Sporting Bulletin no. 4

Subject: Sealing of the Junior CrossCar Restrictors

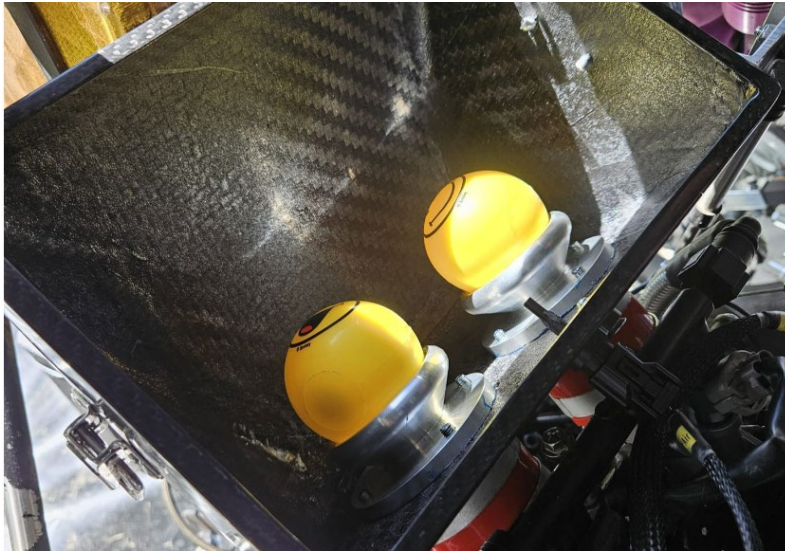
For the 2024 season, all Junior CrossCar restrictors will be sealed. The sealing will be done from the mounting clamps on the restrictors to the mounting clamps on the throttle unit.

The fixing of the restrictors onto the throttle unit must only be carried out with superclamps.

The teams must prepare the heads of the screws of the superclamps with a 2.5-mm bore so that they can be sealed.

The FIA seals will be affixed by the FIA Technical Delegate during the pre-event scrutineering.
